# Access Compliance Report

## Public Rights-of-Way

Intersection ID: 45544	Main Street: HARRIER_RD	Cross Street: CORNIELLE_LN	Location: SW
ADA ID: 6FB787F76753	Ramp Type: Perp	Initial Pass/Fail: Fail	Overall Compliance: No
Codes/Mitigation Info/Possible Solution		Field Measurements/Component Compliance	
Severity Score: 13.75

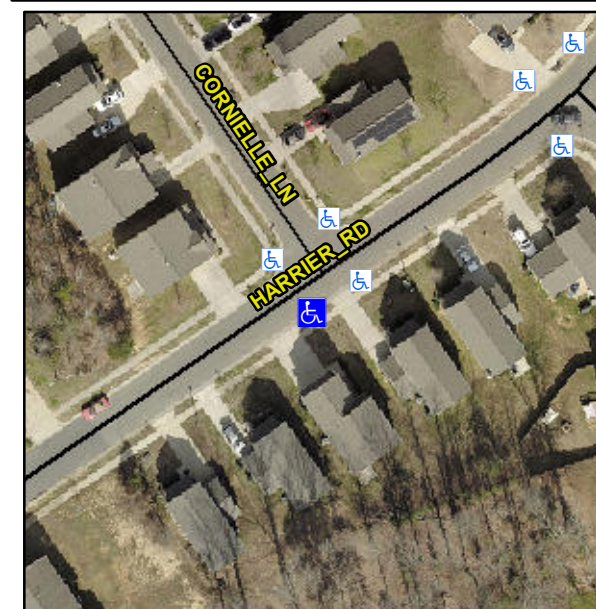
**Not Found, R304.2.2**

Compliance	Description	Data	Compliance	Description	Data
N/A	Ramp Length (in)	46.5	No	Ramp Slope (%)	9.3
Yes	Ramp Width (in)	48.0	Yes	Ramp XSlope (%)	2.3
N/A	Flare Type LT	N/A	N/A	Flare Type RT	N/A
N/A	Flare Slope LT (%)	N/A	N/A	Flare Slope RT (%)	N/A
N/A	Flare Traversable LT?	N/A	N/A	Flare Traversable RT?	N/A
N/A	Landing Length (in)	N/A	N/A	DWS Provided?	N/A
N/A	Landing Width (in)	N/A	N/A	DWS Contrast?	N/A
N/A	Landing Slope (%)	N/A	N/A	DWS Length (in)	N/A
N/A	Landing X Slope (%)	N/A	N/A	DWS Full Width?	N/A
N/A	Landing Curb? (Y/N)	N/A	N/A	DWS Offset (in)	N/A
N/A	Shared Landing?	N/A			
N/A	Gutter Ponding?	N/A	N/A	Gutter Slope (%)	N/A
N/A	Gutter Lip Ht (in)	N/A	N/A	Gutter X Slope (%)	N/A
N/A	Painted X Walk1?	No	N/A	Painted X Walk2?	N/A
	X Walk 1 Direction	To N		X Walk 2 Direction	N/A
N/A	X Walk 1 Width (in)	N/A	N/A	X Walk 2 Width (in)	N/A
	X Walk 1 Slope (%)	1.3		X Walk 2 Slope (%)	N/A
	X Walk 1 X Slope (%)	3.6		X Walk 2 X Slope (%)	N/A

**Remove & Replace Entire Ramp.**
